HISTORIC AND DESIGN REVIEW COMMISSION

October 16, 2019

HDRC CASE NO: 2019-591
ADDRESS: 145 E MAGNOLIA AVE
LEGAL DESCRIPTION: NCB 1703 BLK 8 LOT 26, E10 FT OF 25
ZONING: MF-33, H
CITY COUNCIL DIST.: 1
DISTRICT: Monte Vista Historic District
APPLICANT: Deyanira Flores
OWNER: Djuan & Tamica Hales
TYPE OF WORK: Exterior modifications to a side porch
APPLICATION RECEIVED: September 20, 2019
60-DAY REVIEW: November 19, 2019
CASE MANAGER: Huy Pham
REQUEST:

The applicant is requesting a Certificate of Appropriateness to enclose the side porch with eleven vinyl windows.

1 - SOUTH ELEVATION

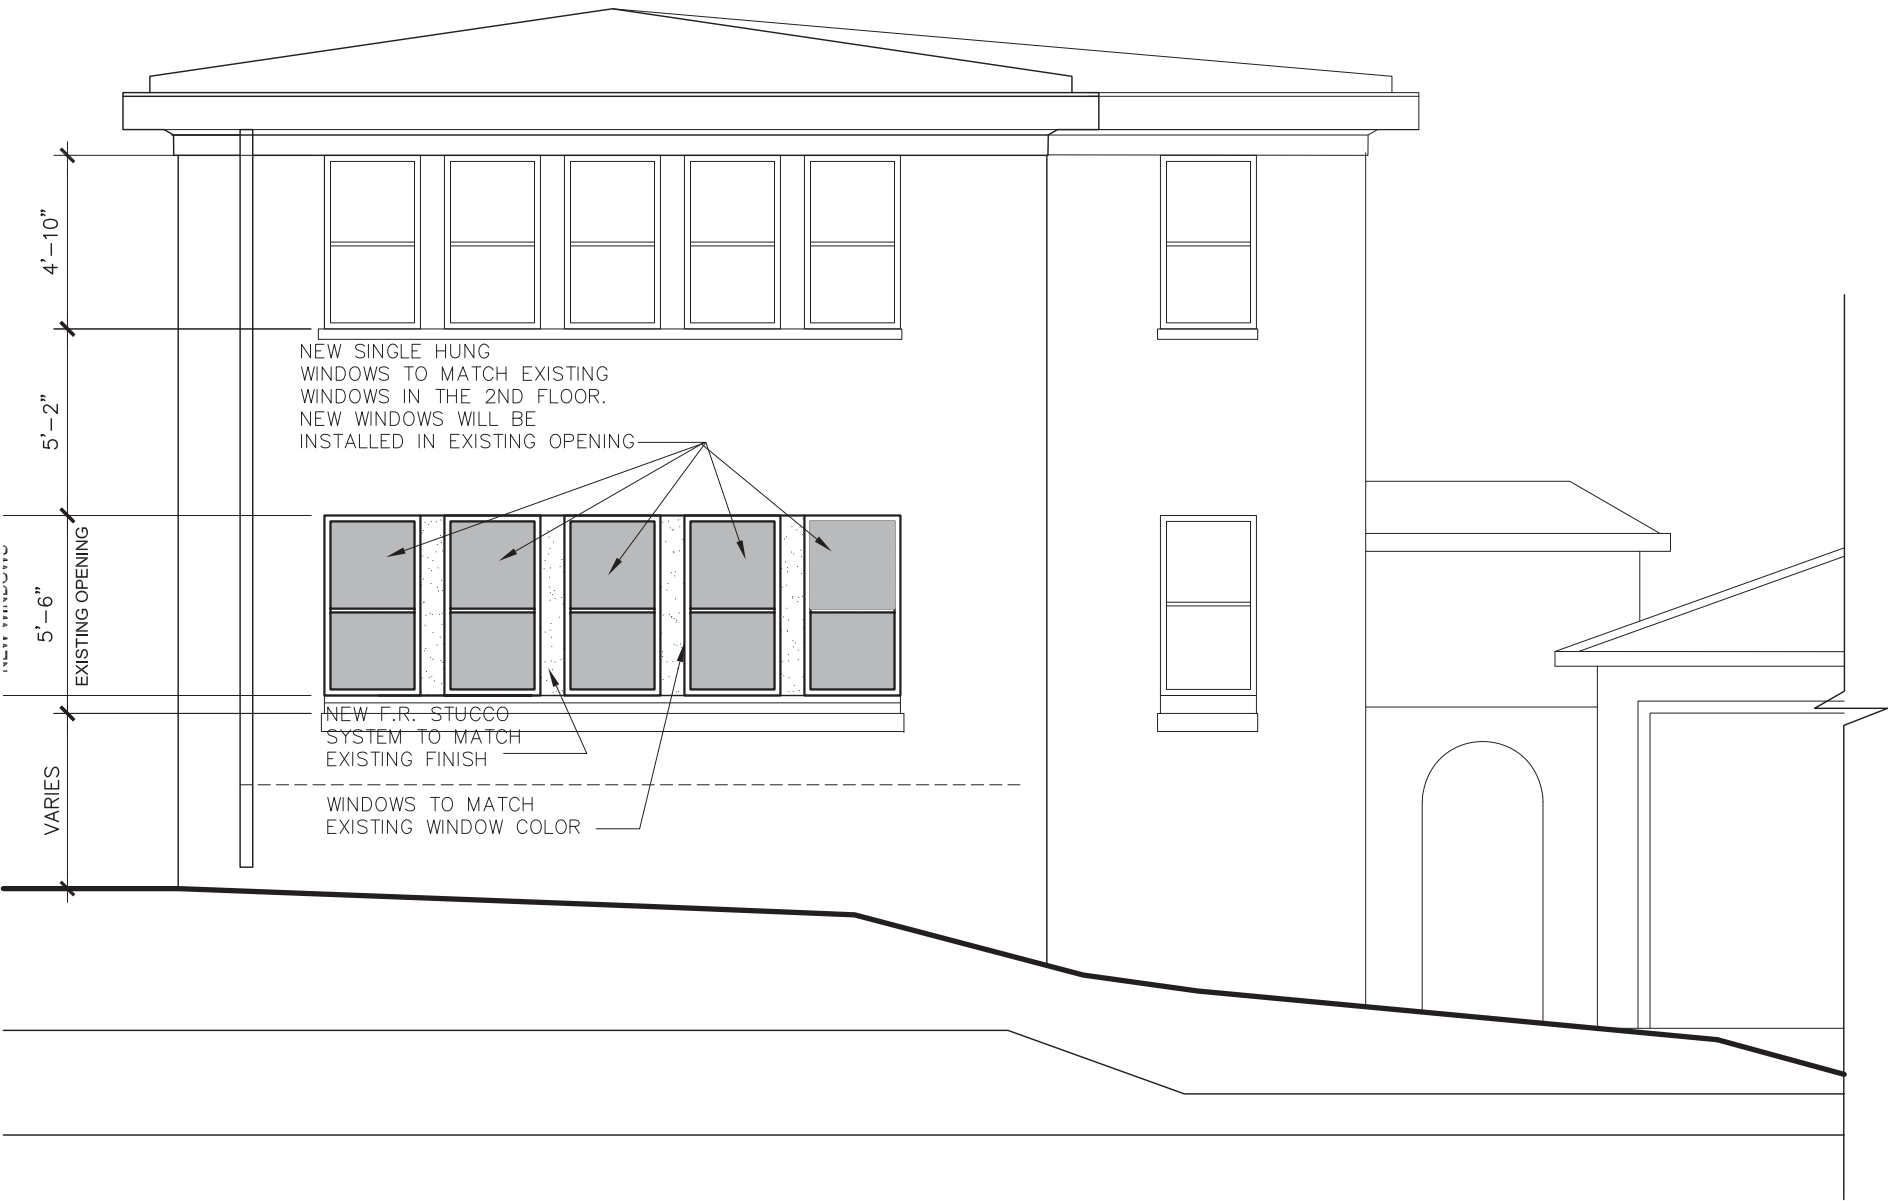
- b. **SIDE PORCH ENCLOSURE** – The applicant has proposed to enclose the first-floor side porch to match the fenestration pattern on the second floor. The enclosure will feature windows that match in size and configuration to the second floor, but will feature vinyl instead of wood. Per the Guidelines for Exterior Maintenance and Alterations 7.B.ii., side and rear porches should not be enclosed, particularly when connected to the main porch or balcony; original architectural details should not be obscured by any screening or enclosure materials; alterations to side and rear porches should result in a space that functions, and is visually interpreted as, a porch. Staff finds that the side porch is a character-defining feature of the structure; however, staff finds that an enclosure that reads as a non-original porch and is reversible would be appropriate. Additionally, per the standard specifications for new window installation, the new windows should feature wood or aluminum-clad wood instead of vinyl.

Staff recommends approval of side porch enclosure based on finding b with the stipulation that enclosure should be reversible and that the new windows are wood or aluminum-clad wood rather than vinyl and feature the standard specifications.
